TECHNICAL INFORMATION BULLETIN

Bulletin N° 2007/219

Falcon II Outdoor and Rockhopper II

New Firmware rh3.00

- **2x4 and 1x6 ink setup**

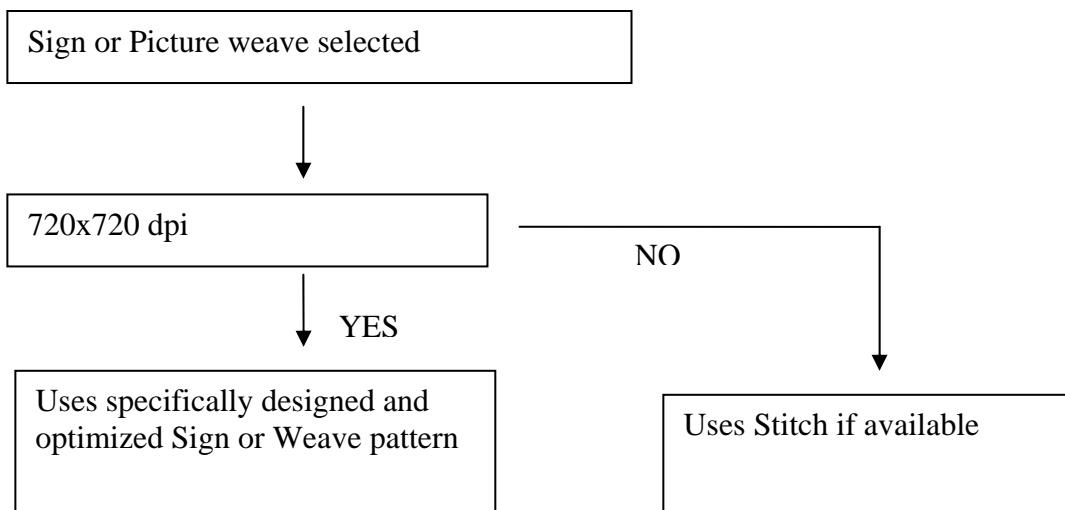
The i²-feature is available for '2x4' ink setups and '1x6' ink setups.

Weaving sign and picture are only available in 720x720 printmodes.

When sending a file with an unsupported weave configuration, the stitch setting will be used.

Stitch mode is available in all 1pass and 2pass modes.

Stitch mode is unavailable in all 4pass modes.

2.2. Scan Width

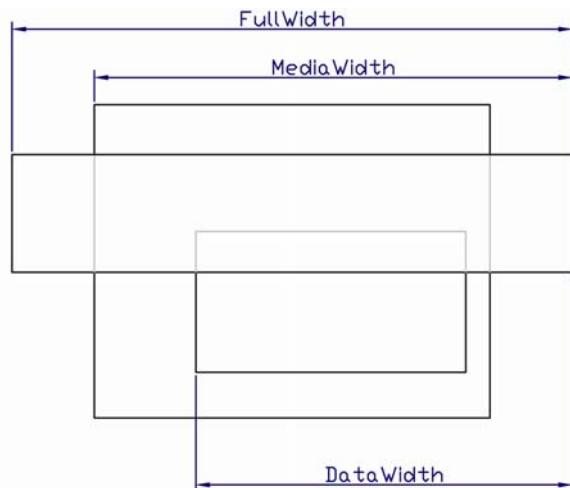
This new feature appears as a new menu item in the “Print Mode” menu. The aim of this feature is to provide better control over ink drying.

Setup items	Parameters	Description	Drying time
ScanWidth	DataWidth	Carriage moves only over the printing area	Short
	MediaWidth	Carriage moves to the end of the media	Depending on MediaWidth
	FullWidth	Carriage moves over the full width of the printer	Long
